Product Change Notification

Product Change Notification: E-21-003104

T9A series relay

Marking change compare

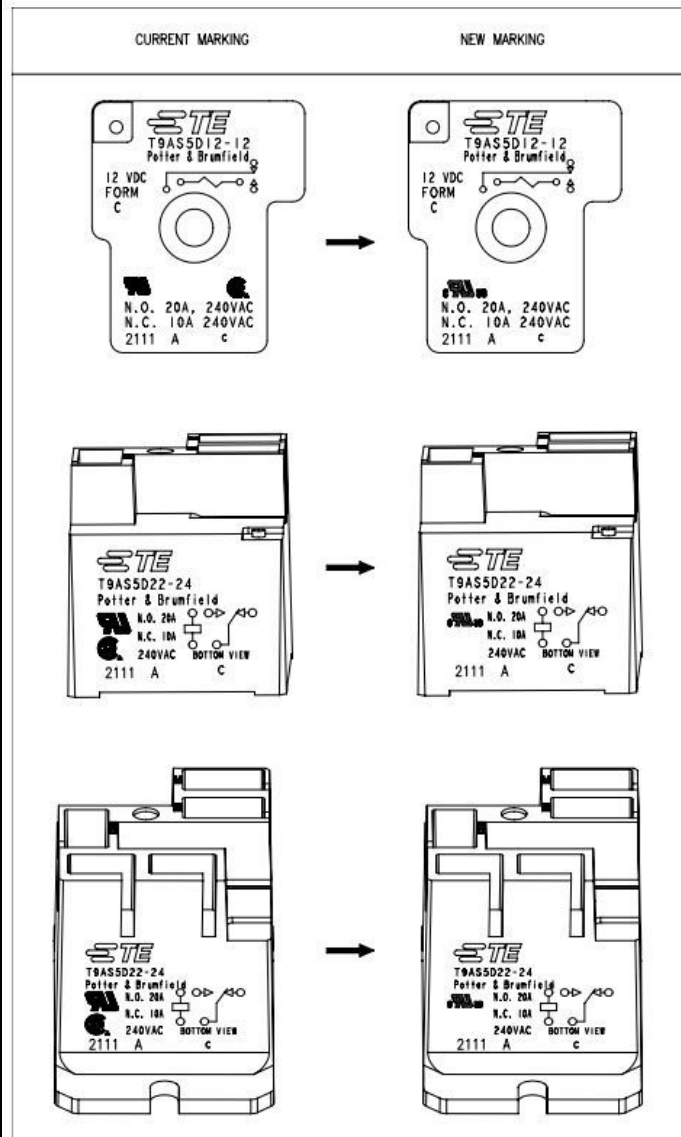
Change UL agency approval mark from RU to cRUus, and remove CSA mark. Product still meet two standards UL508 and CSA C22.2 NO.14-13. no any function and performance change, only appearance marking change.

Marking change compare

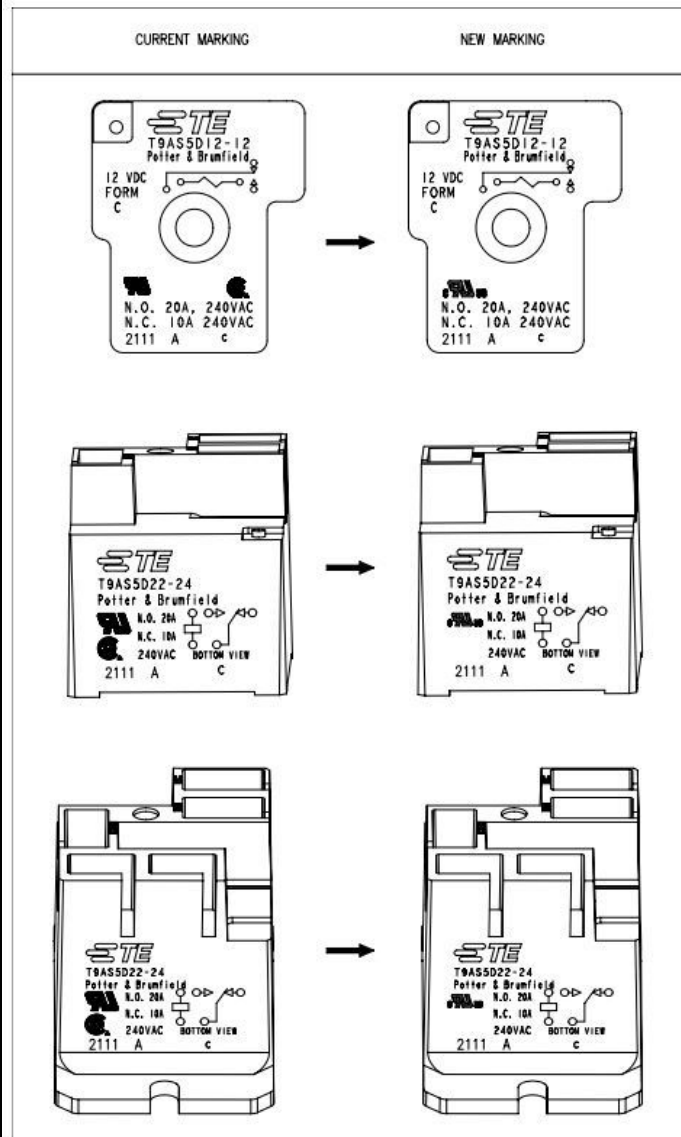
Change UL agency approval mark from RU to cRUus, and remove CSA mark. Product still meet two standards UL508 and CSA C22.2 NO.14-13. no any function and performance change, only appearance marking change.
